Product Change Notification

Change Notification #: 115210 - 00
Change Title: 2U Dual Port Hot-swap Drive Cage
Upgrade Kit 8 x 2.5" A2U8X25S3DPDK,
PCN 115210-00,
Product Design, Remove connectors
J3B3 and J3B4

Date of Publication: January 06, 2017

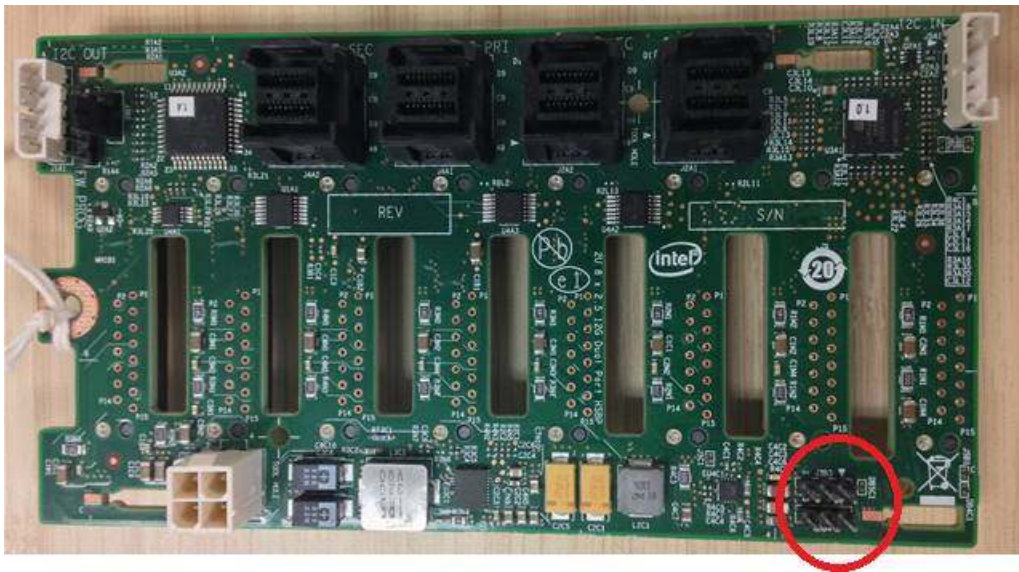
Intel will remove the debug connector J3B3 and J3B4 from the Hot Swap Backplane in the Intel® Server kit A2U8X25S3DPDK. The debug connectors are not required for the proper function of the Intel Server kit.
